RE: Recall Number 06V-356 Defect Information Report (additional information)
(Hyundai Campaign 078)

Group	CAMPAIGN
Number	06-01-010
Date	OCTOBER, 2006
Model	2007 ENTOURAGE

Subject
**STOP LAMP SWITCH WIRING
 SERVICE CAMPAIGN 078**

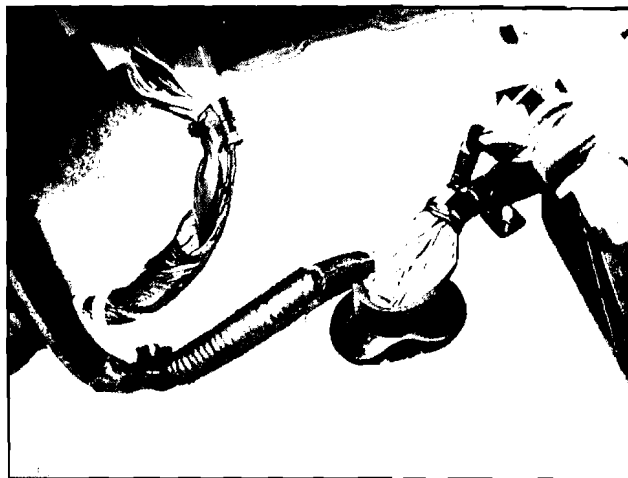
3. Locate the stop lamp switch wiring as shown in photo.

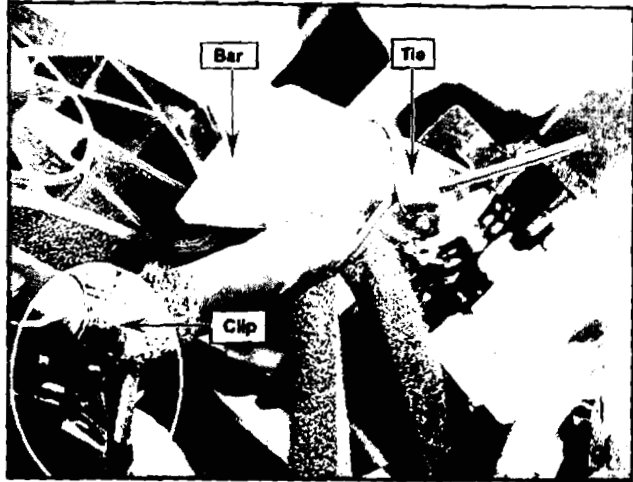
4. Tie the stop lamp switch wiring and the front wiring harness with a plastic tie wrap as shown in the photo. This procedure will pull the stop lamp switch wiring to the arrow direction to create a gap between the wiring and the steering column shaft.

5. Tie wrap the stop lamp switch wiring to the steering column shaft guide bar. Verify that the clearance between the stop lamp switch wiring and the steering column shaft is 26 mm (~1 inch) or more.
6. Cut off the excess plastic tie wrap. Be careful not to damage the vehicle's wiring.
